ADDENDUM NO. 2

Rochester City School District

Dr. Walter Cooper, School #10

February 28th, 2018

S2005

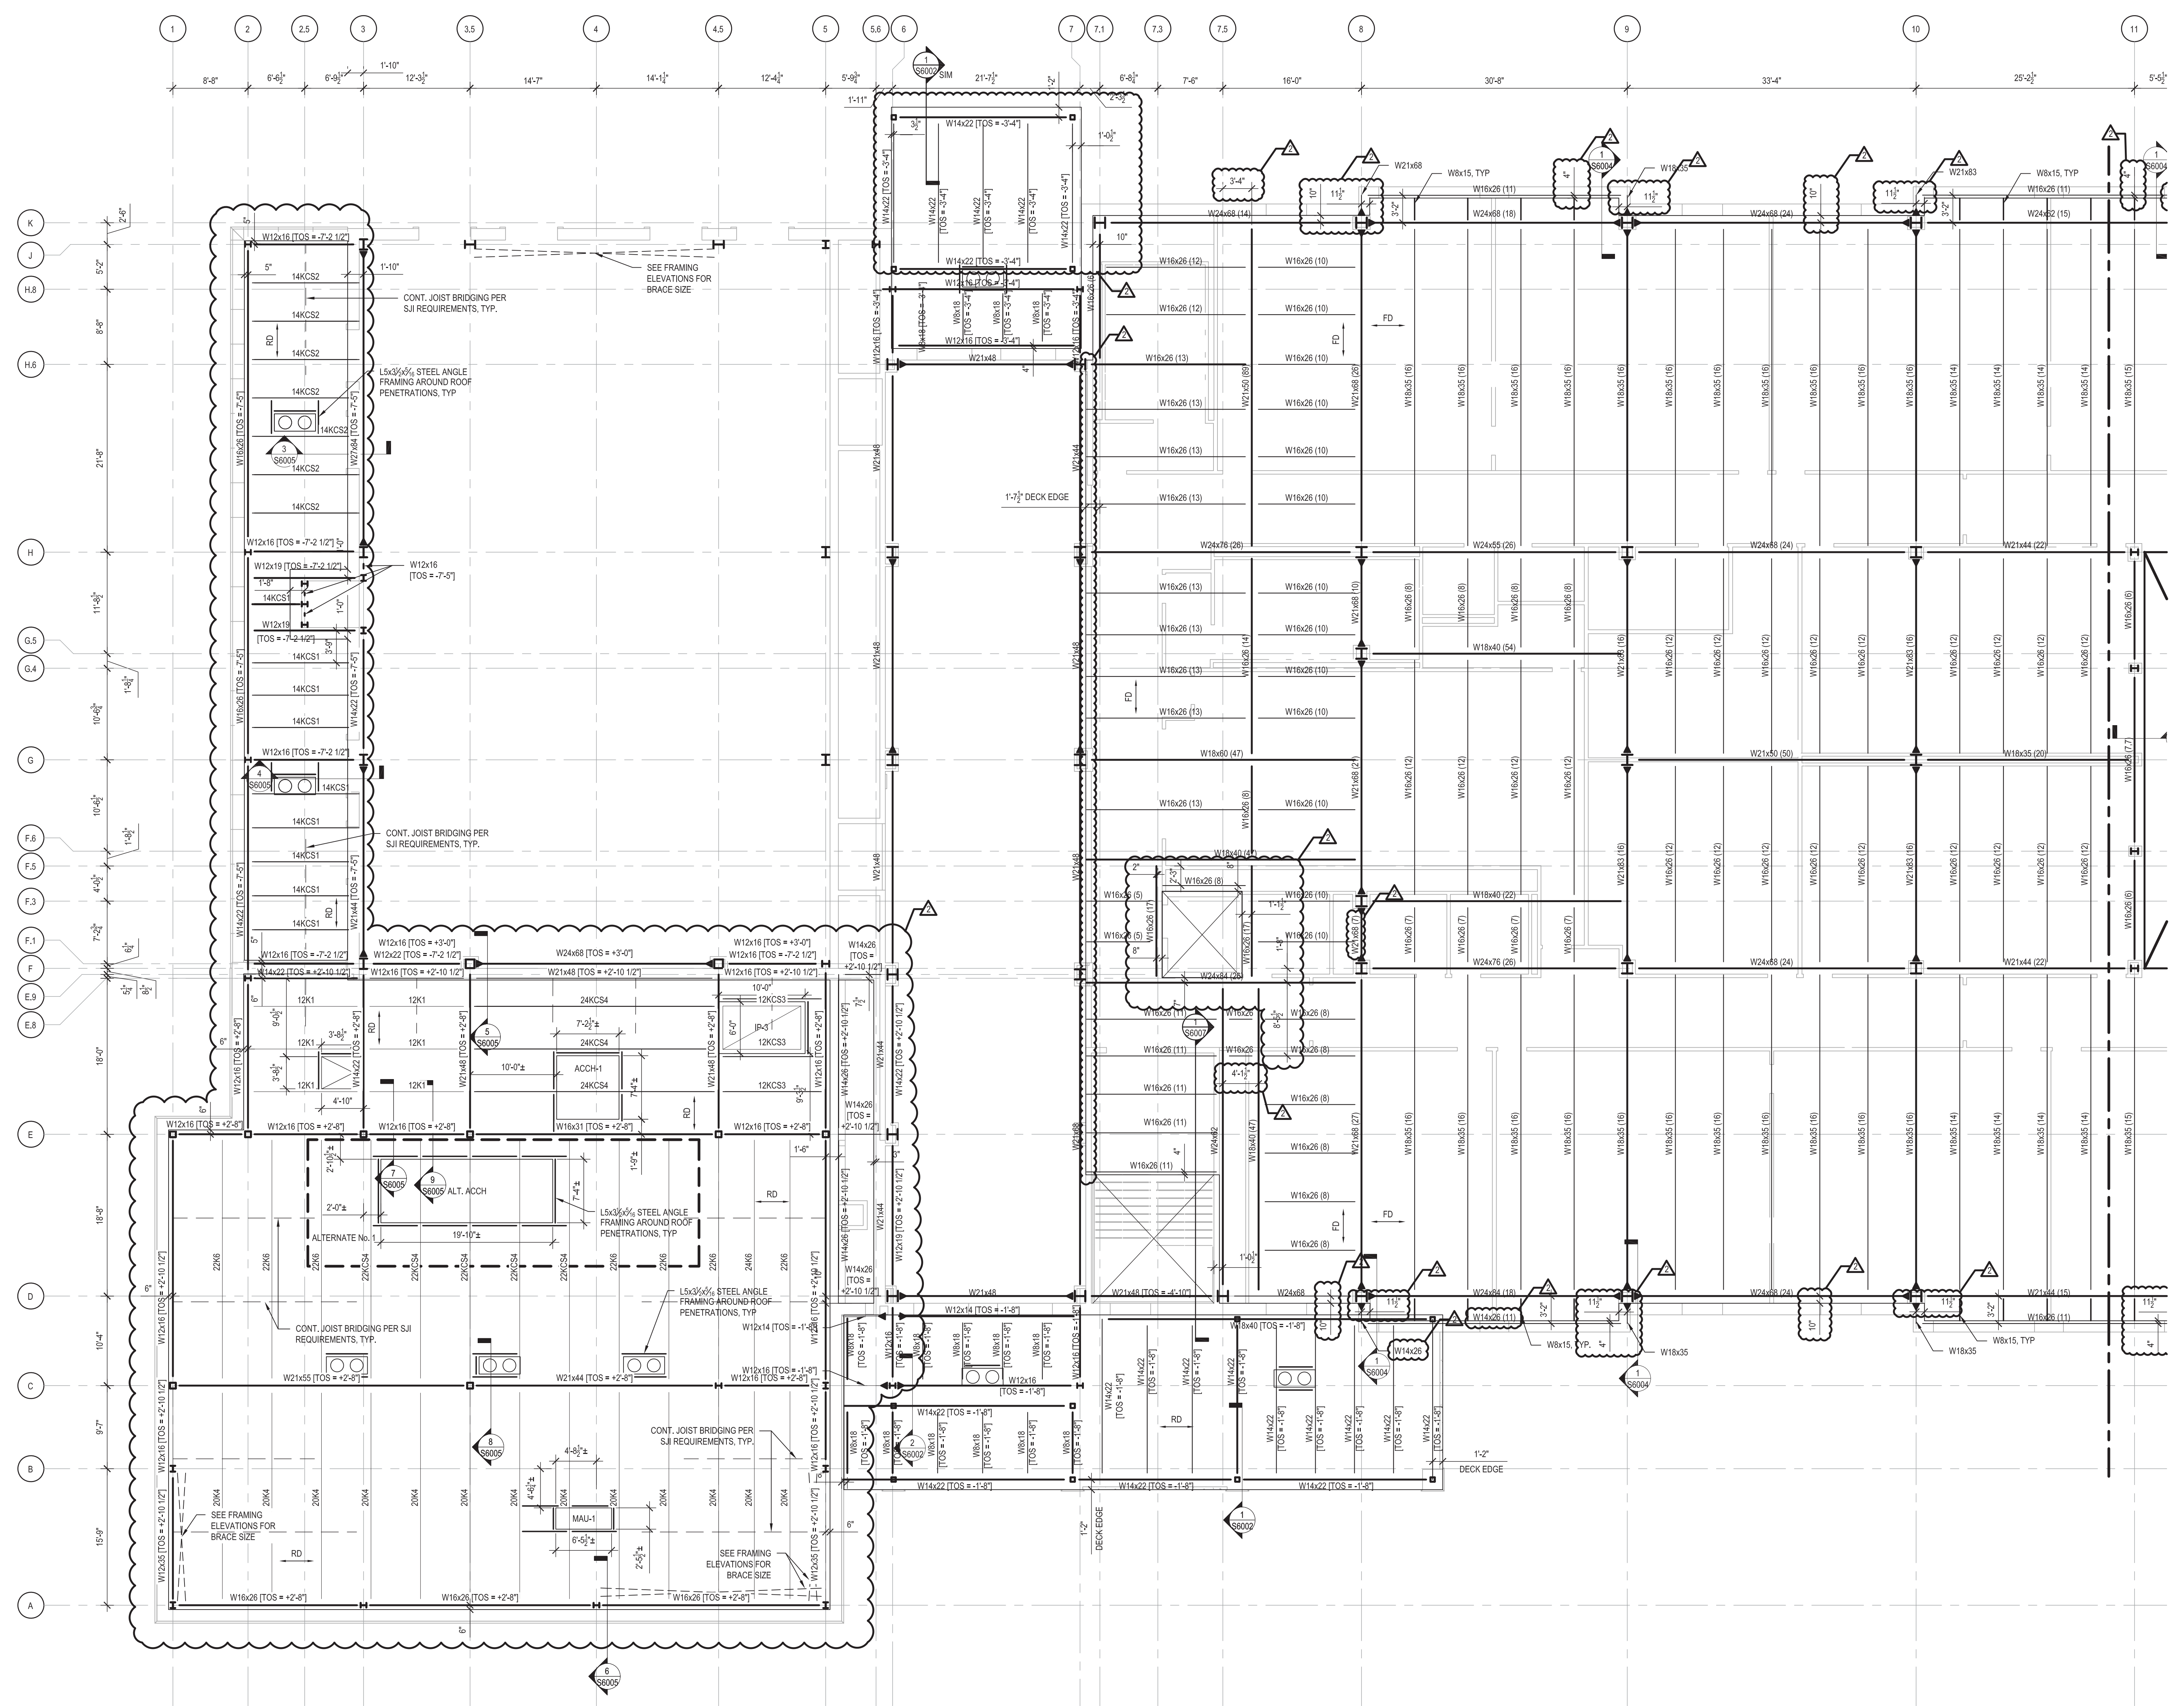
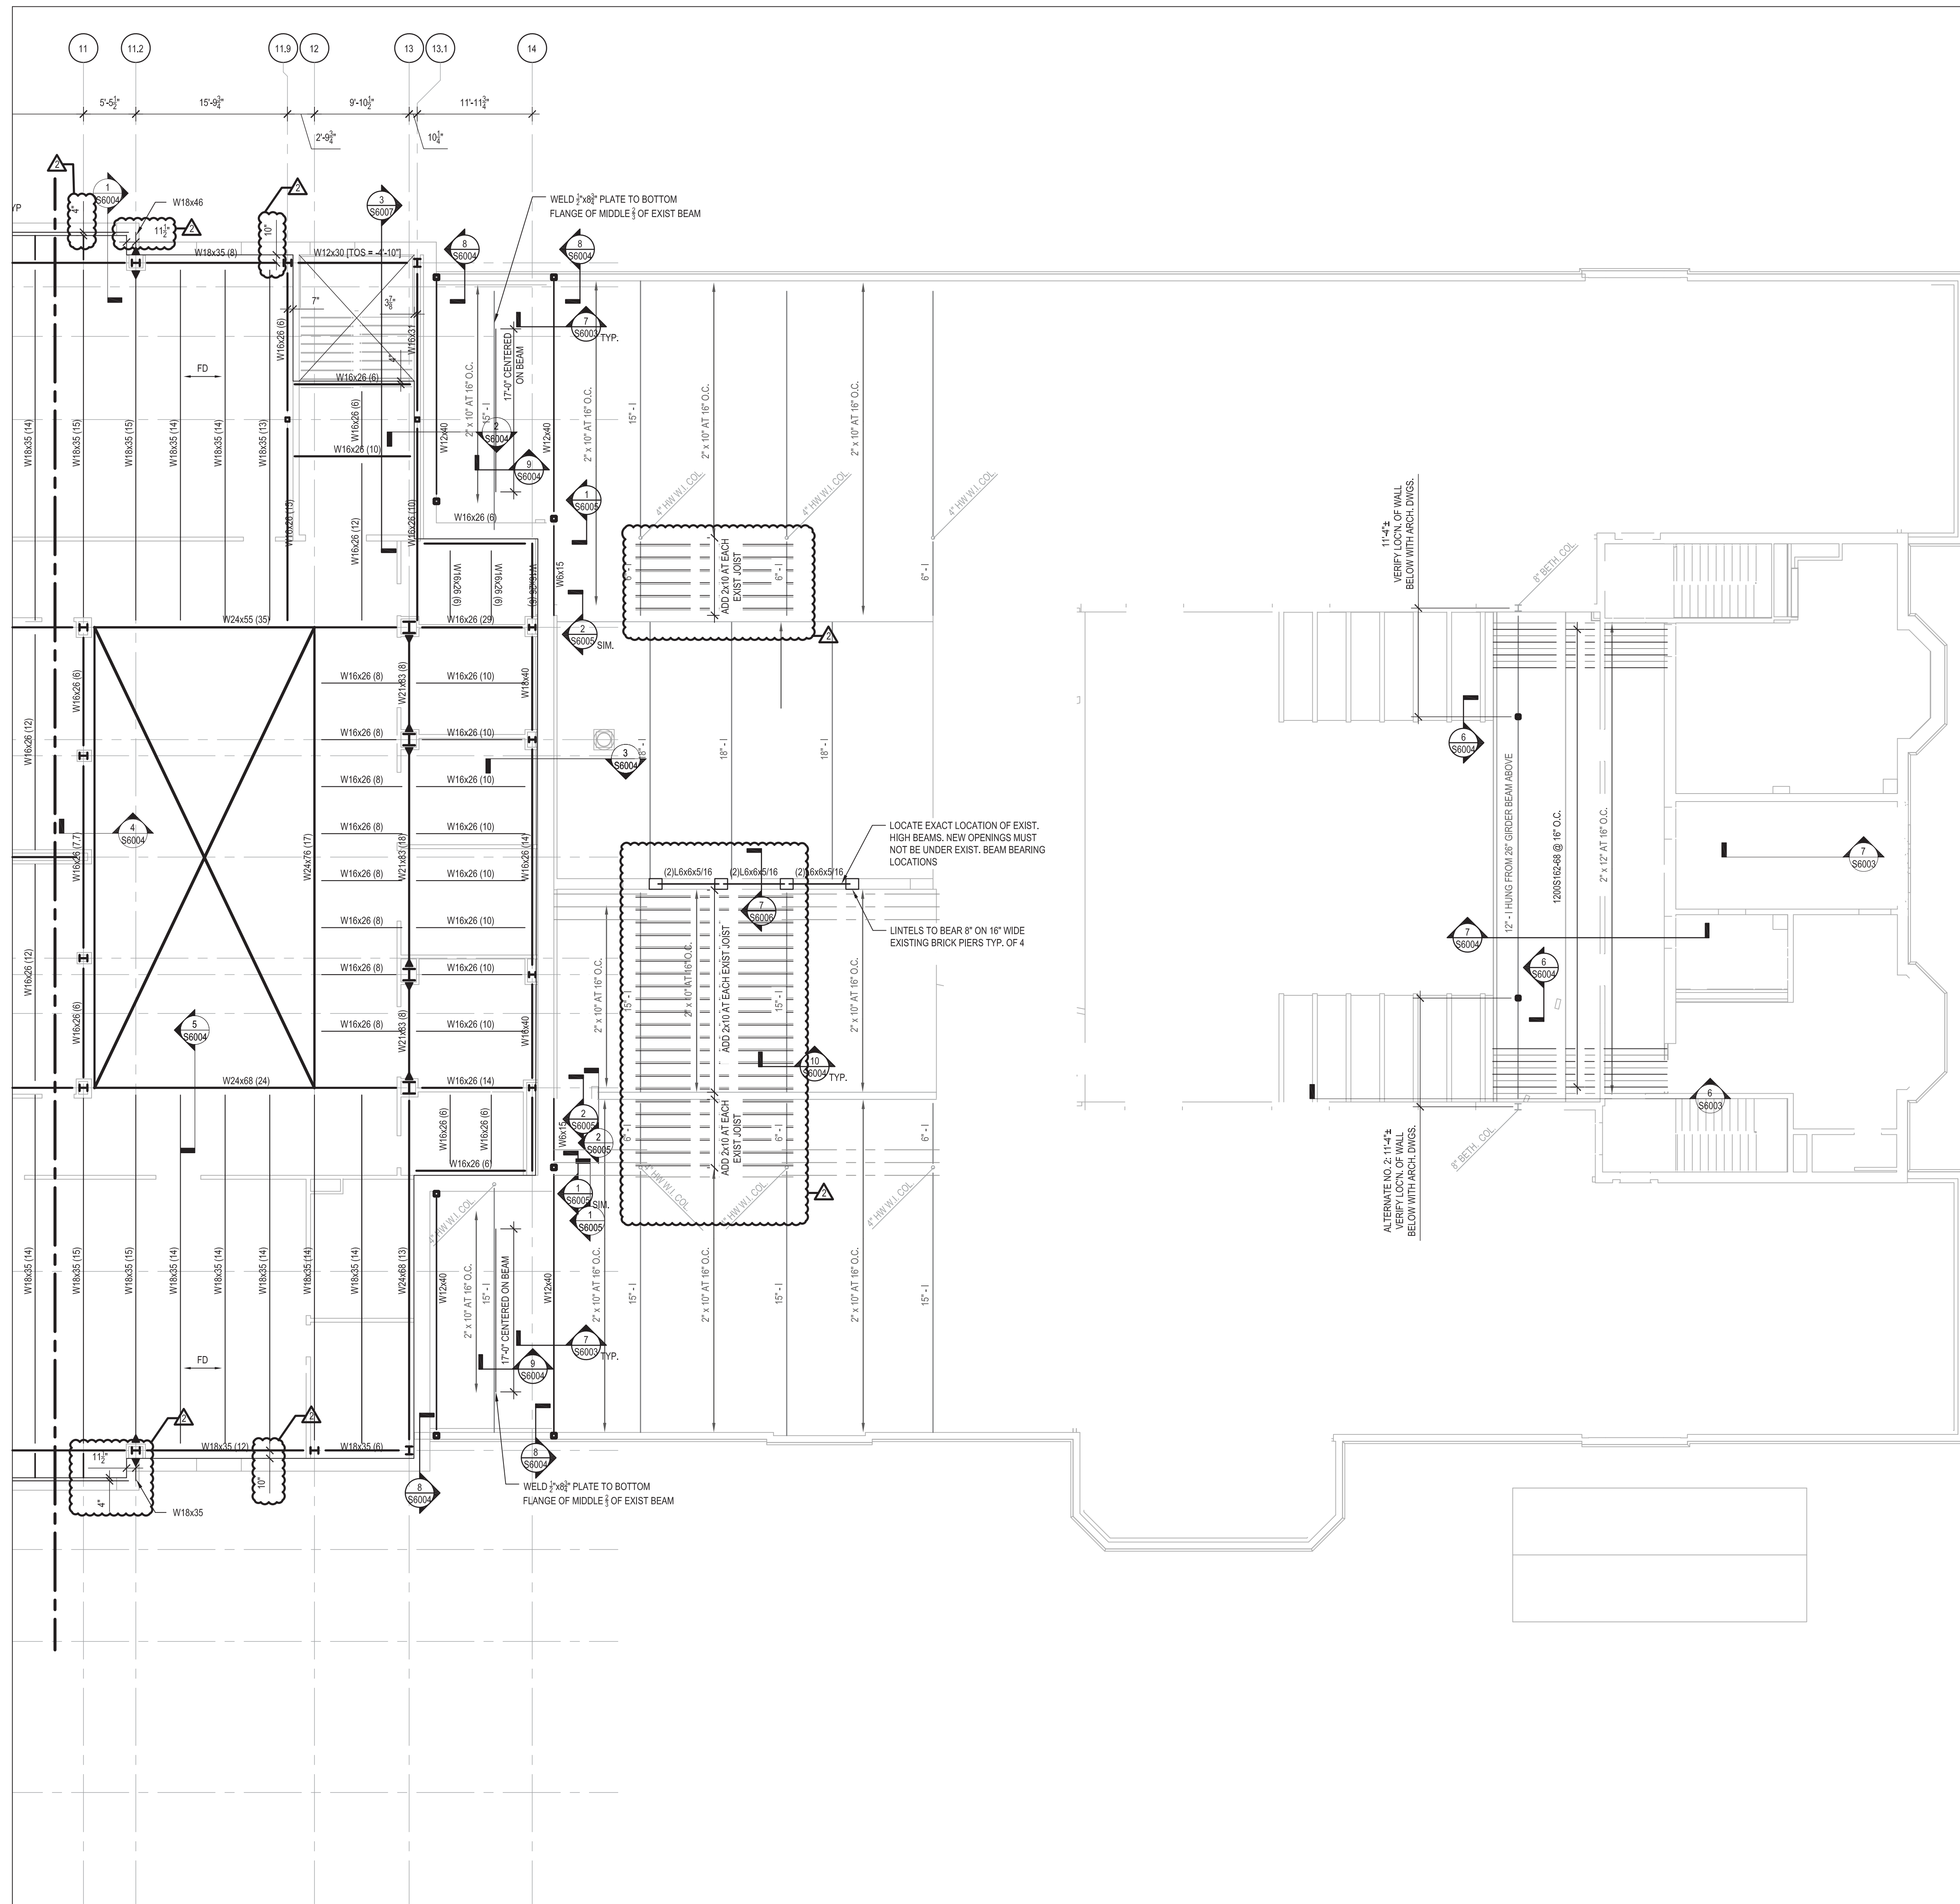
Item AD2-19 **REPLACE** drawing in its entirety with attached “S2005 – PARTIAL SECOND FLOOR AND ROOF FRAMING PLAN.” Revised top of steel elevations for the cafeteria and storage area south of gym and west entrance canopy; revised steel beam sizes over the chase north of cafeteria; revised steel beam and steel joist sizes in the cafeteria; revised steel beams sizes of bay window over east canopy; revised framing and deck over chase south of east canopy; revised deck edge dimensions at the storage roof,

cafeteria, and second floor; revised deck opening dimensions at elevator shaft and chase next to west staircase; and revised dimensions to beam north of grid line 7.3.

H1300

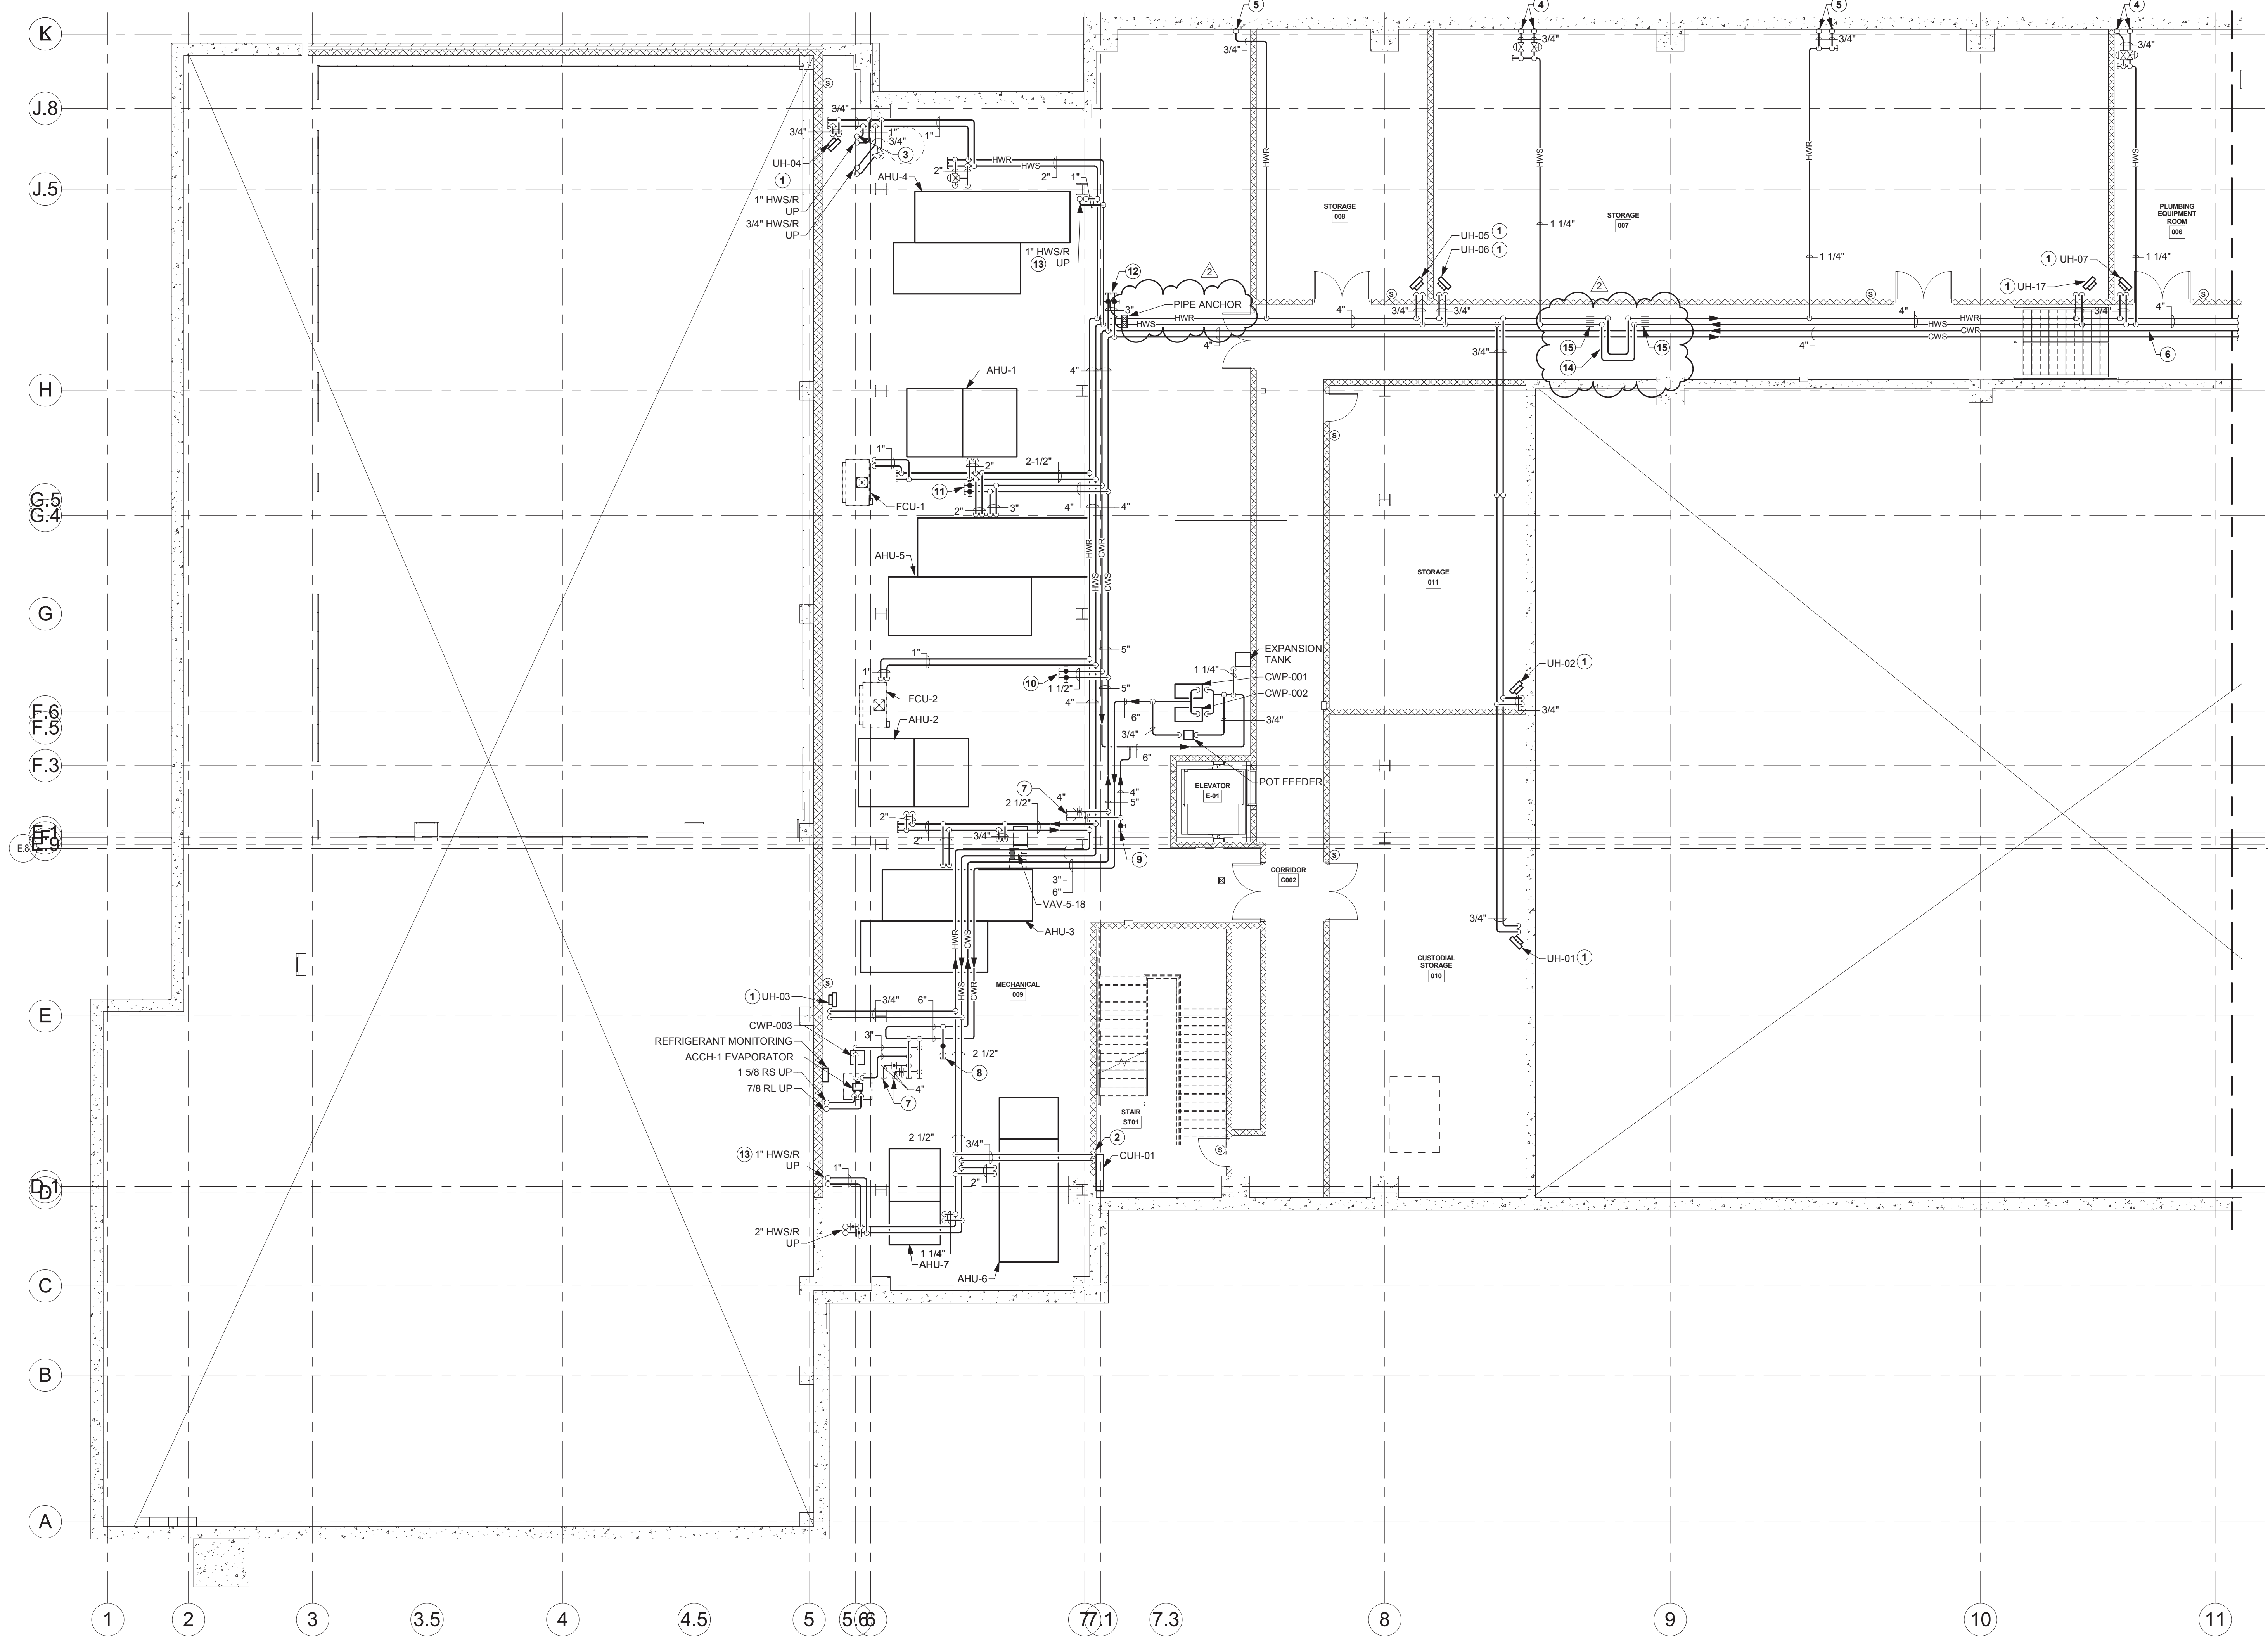
- Item AD2-36 **REPLACE** drawing in its entirety with attached “H1300 – PARTIAL LOWER LEVEL PLAN – HVAC PIPING.” Add piping anchors, guides and expansion loop to heating water piping.
